# COMMITTEE OF ADJUSTMENT

**MINOR VARIANCE REPORT**

**APPLICATION: CAV A/099/2024**

**CAV A/099/2024 – 26 Holyrood Avenue (West District)** (OP Designation: Low Density Residential and Waterfront Open Space)

*Street View of subject lands – 26 Holyrood Avenue (vacant site) and the neighbouring dwellings abutting the property to the west, at 32 Holyrood Avenue (not visible in photo) and 38 Holyrood Avenue (right side of photo)*

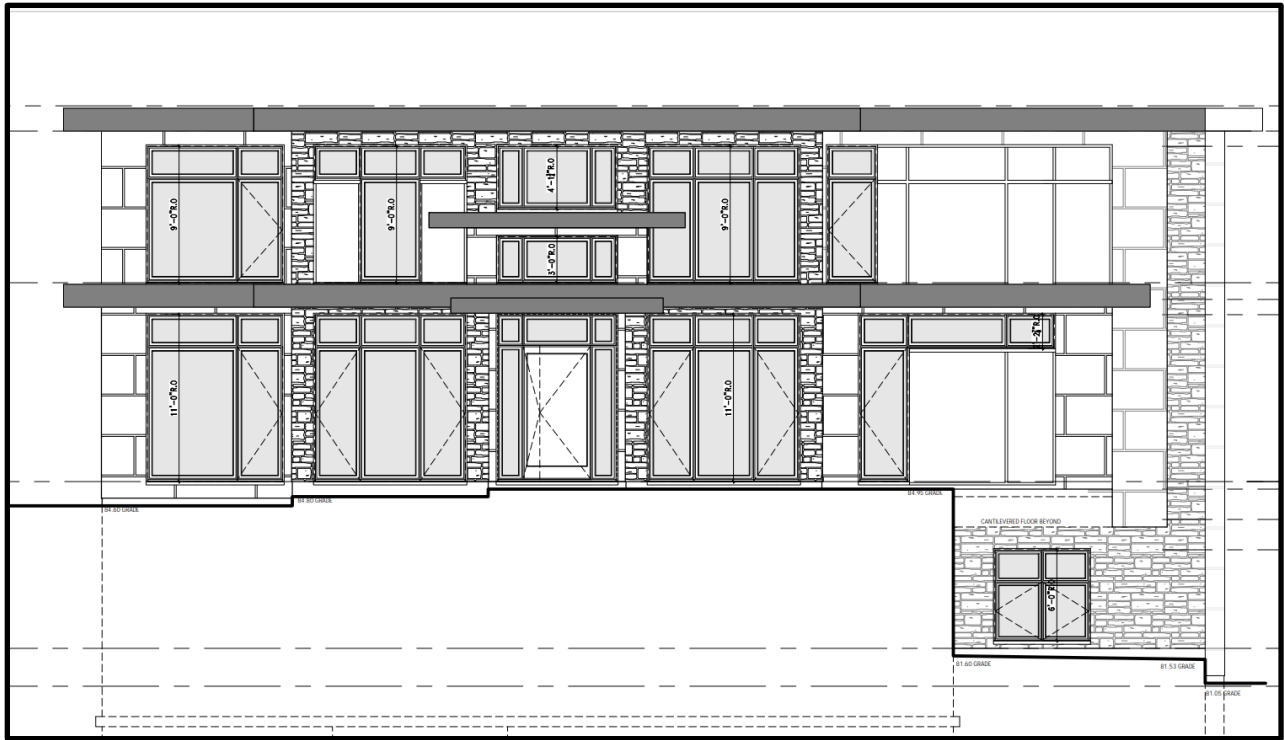
Holyrood Avenue is a cul-de-sac street which contains a crescent providing access to three properties. The subject site is situated along this portion of the crescent and is adjacent to a public walkway that provides access to Holyrood Park. The property has an irregular topography and falls within Conservation Halton's regulated area limits as it abuts Lake Ontario. The site is currently vacant as the previous dwelling was demolished in 2022.

*Street View of the neighbouring two-storey dwellings located on the east side of Holyrood Avenue, opposite the subject lands*

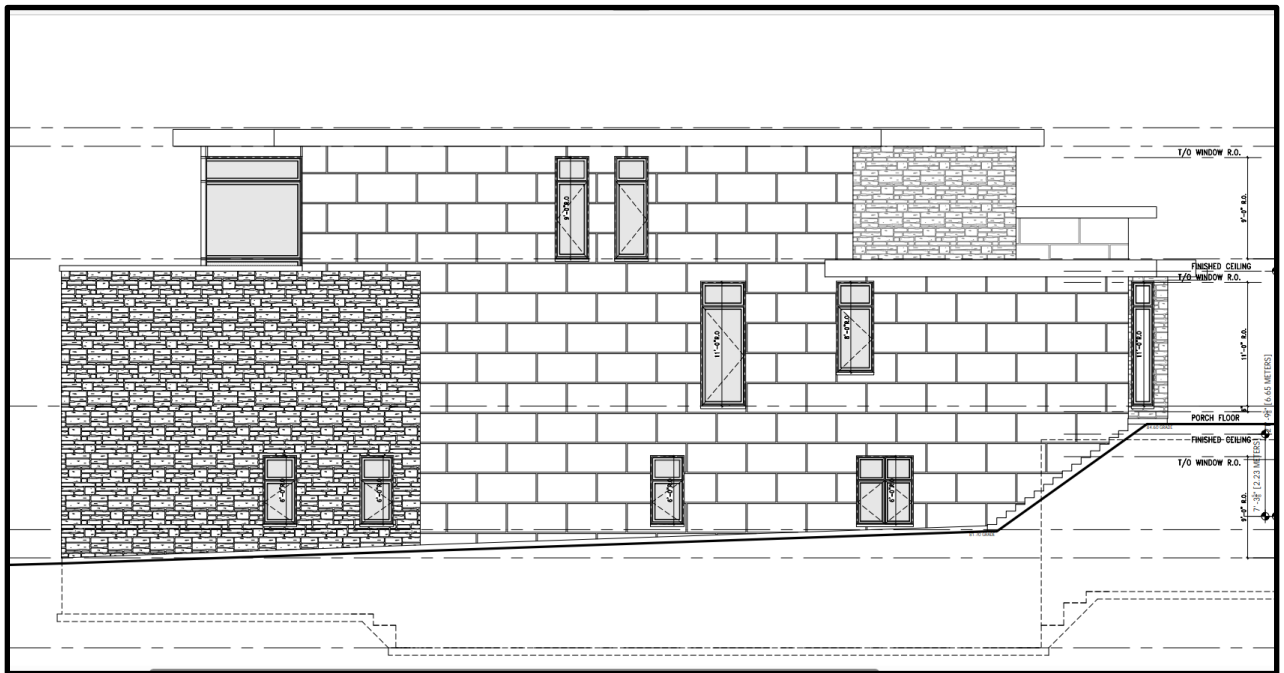
The neighbourhood consists of predominately one and two-storey dwellings that are original to the area and newly constructed two-storey dwellings. Most of the recently constructed dwellings include attached two-car garages and consist of lower second floor roof lines, stepbacks, and massing broken up into smaller elements to help reduce potential impacts on the streetscape.
